City of Wilsonville
Exhibit B1 DB20-0002 et seq

PROJECT #180146.03

Planning Division
Development Permit Application

New 11,400 sf metal building with an approximately 52,700 sf open storage yard.

1 SOUTH ELEVATION
A2.1 1/8" = 1'-0"

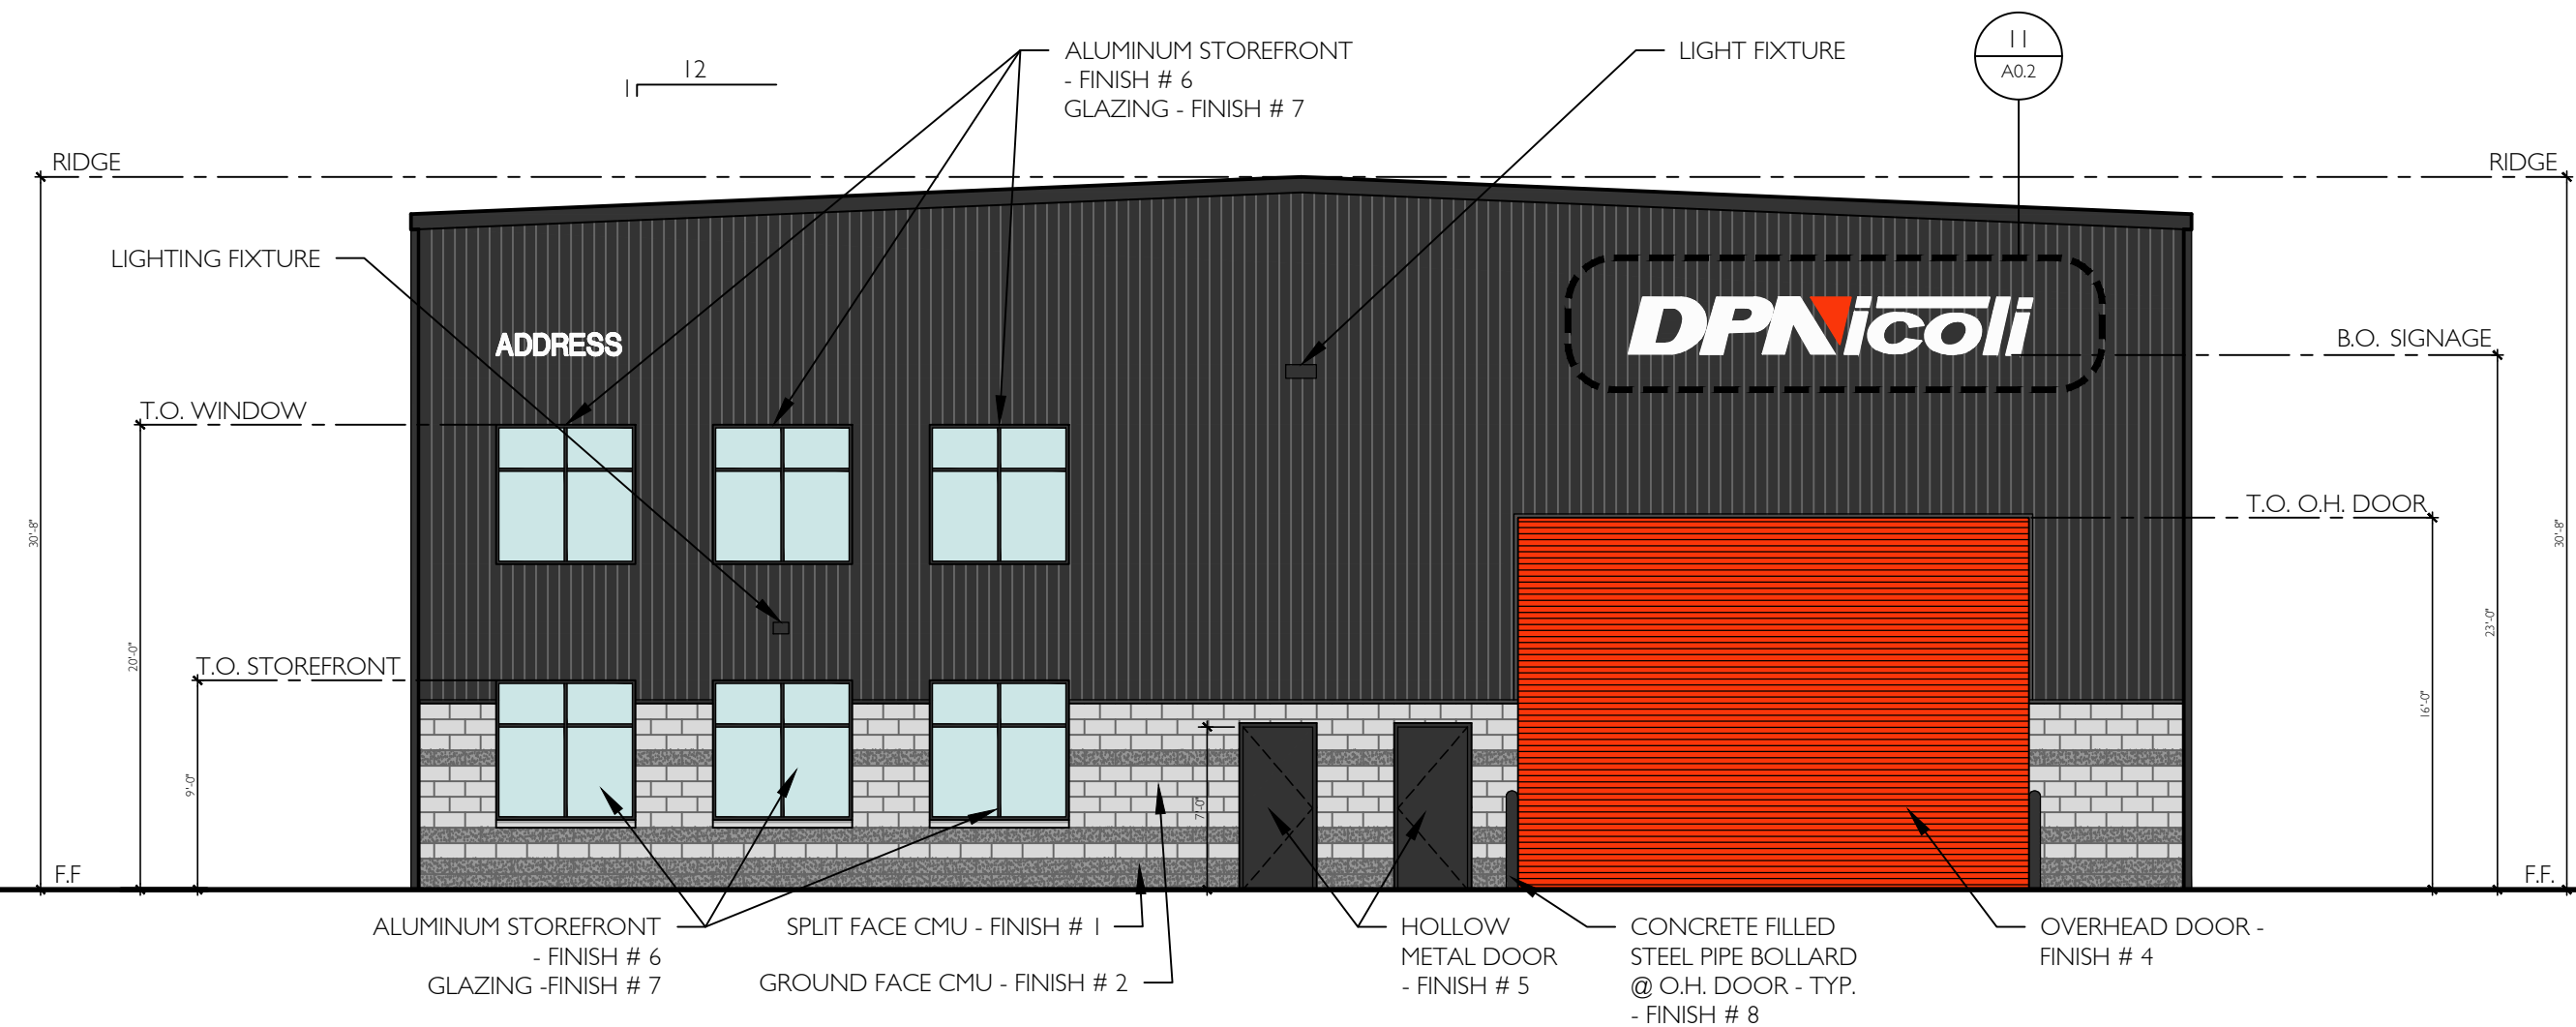
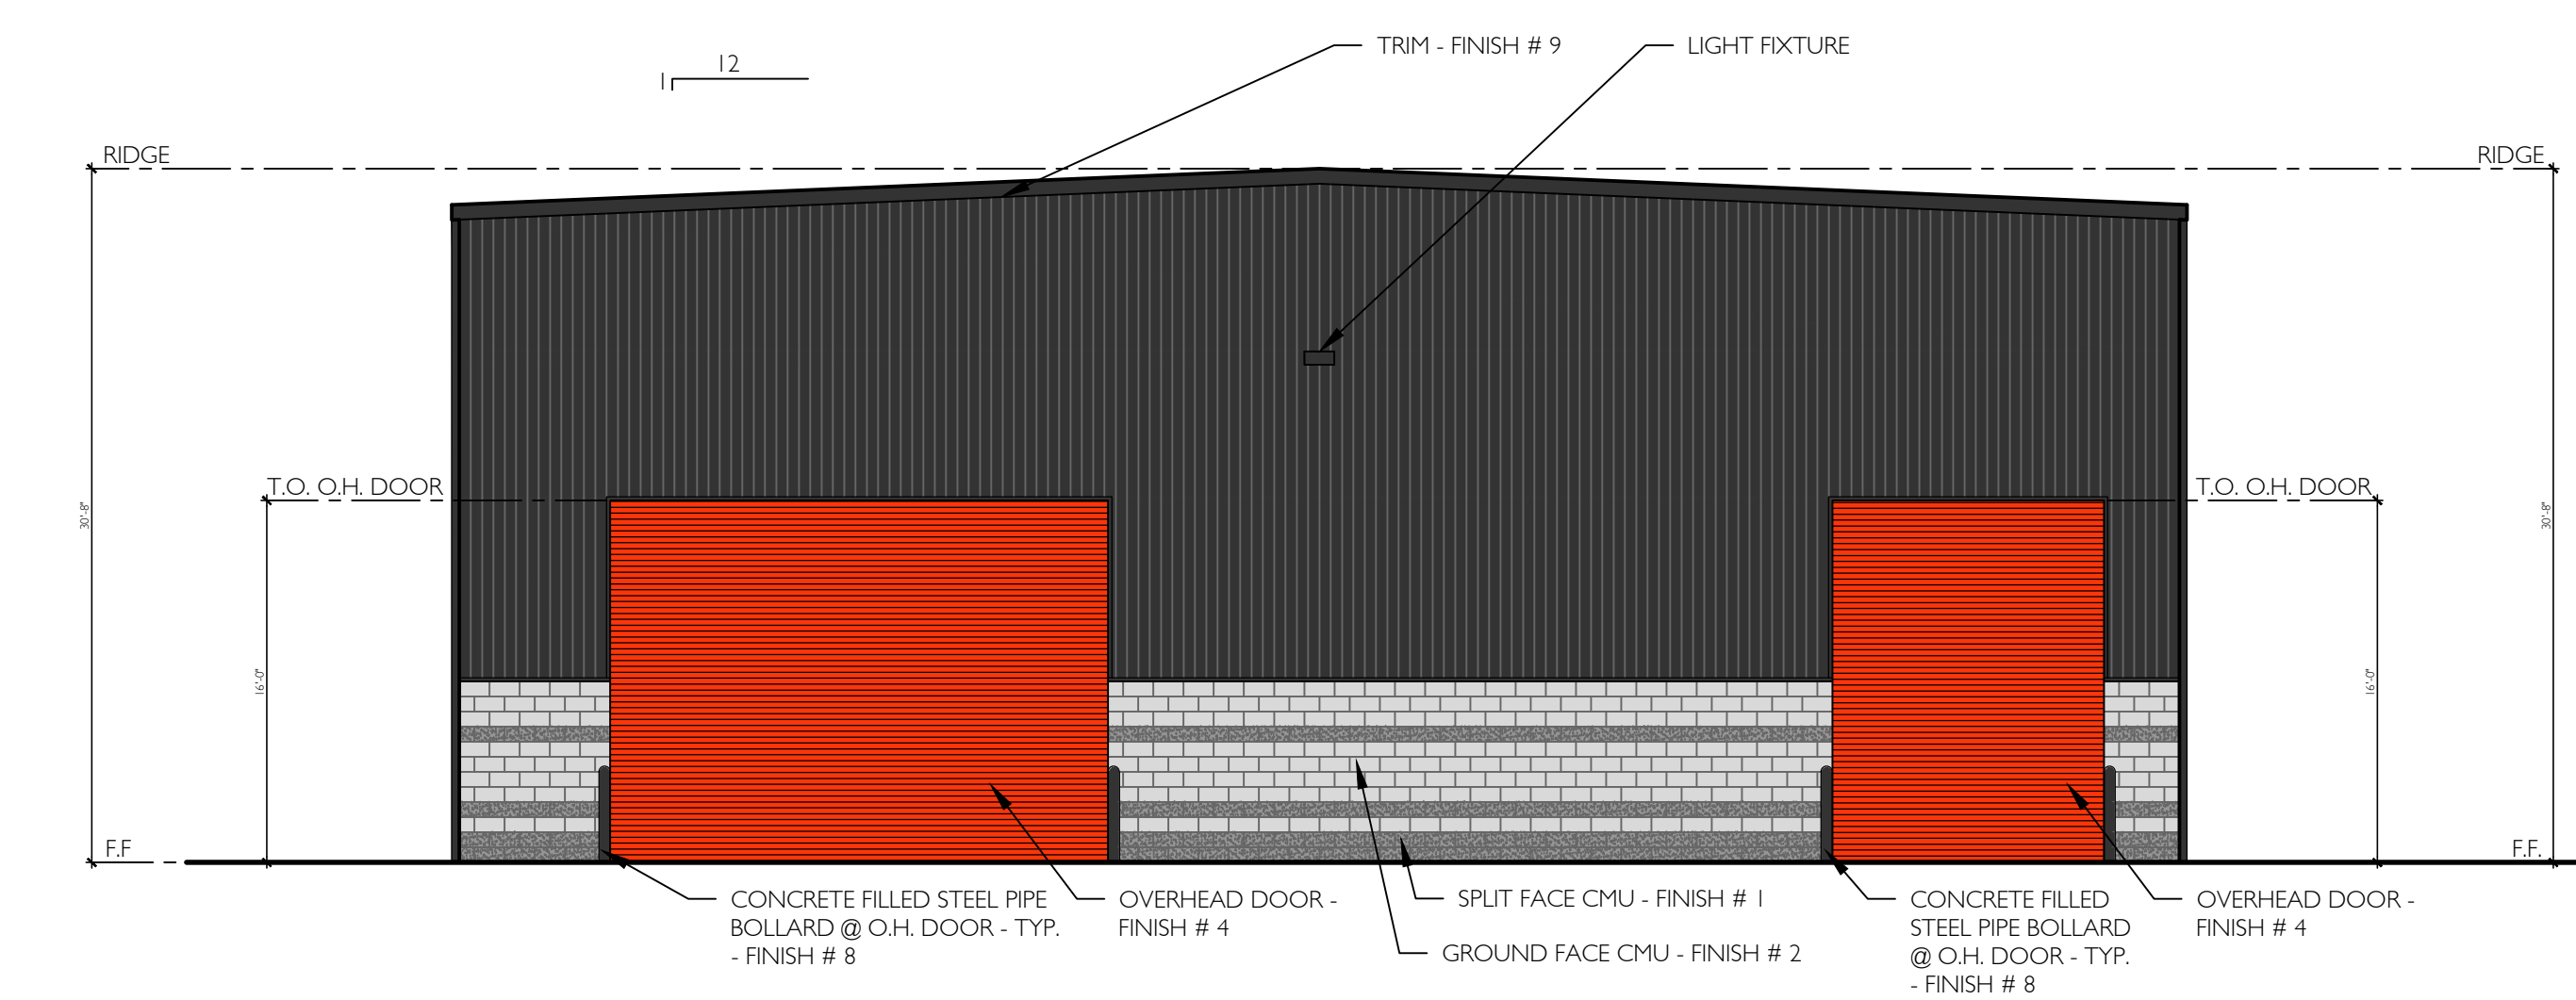
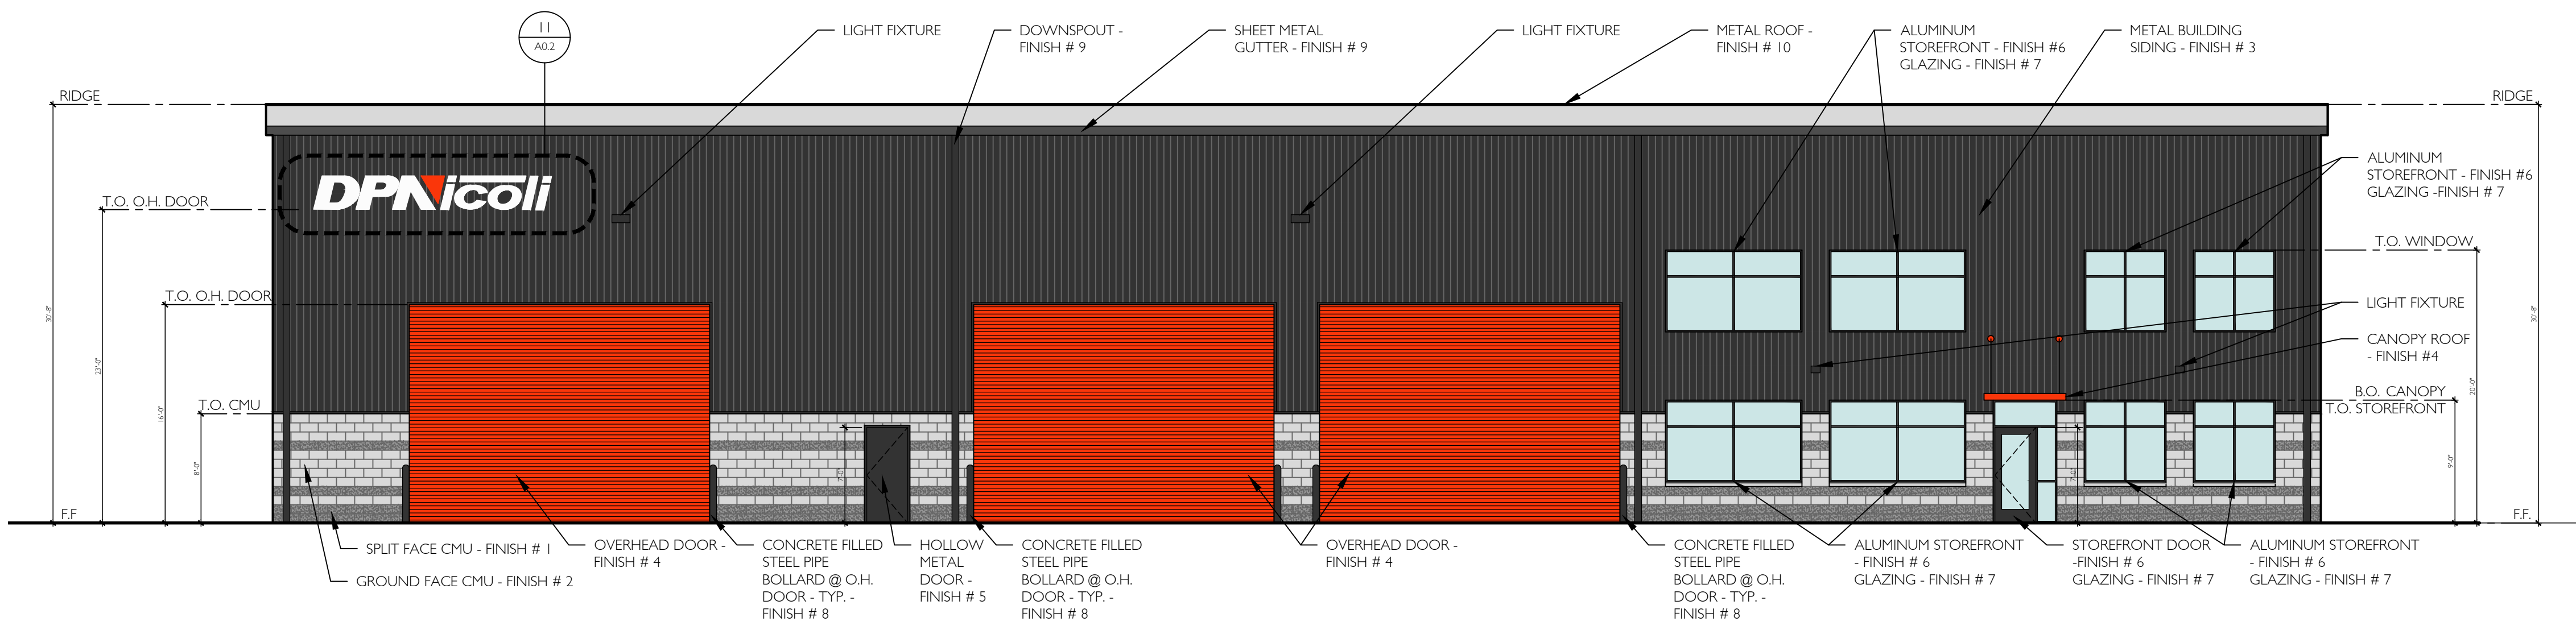
- f. Section 4.156 Sign Regulations
 - i. .01 (.01) F. – Response states “three building mounted signs” are proposed; Exterior Elevations (Sheet A2.1) shows two signs; correct this inconsistency
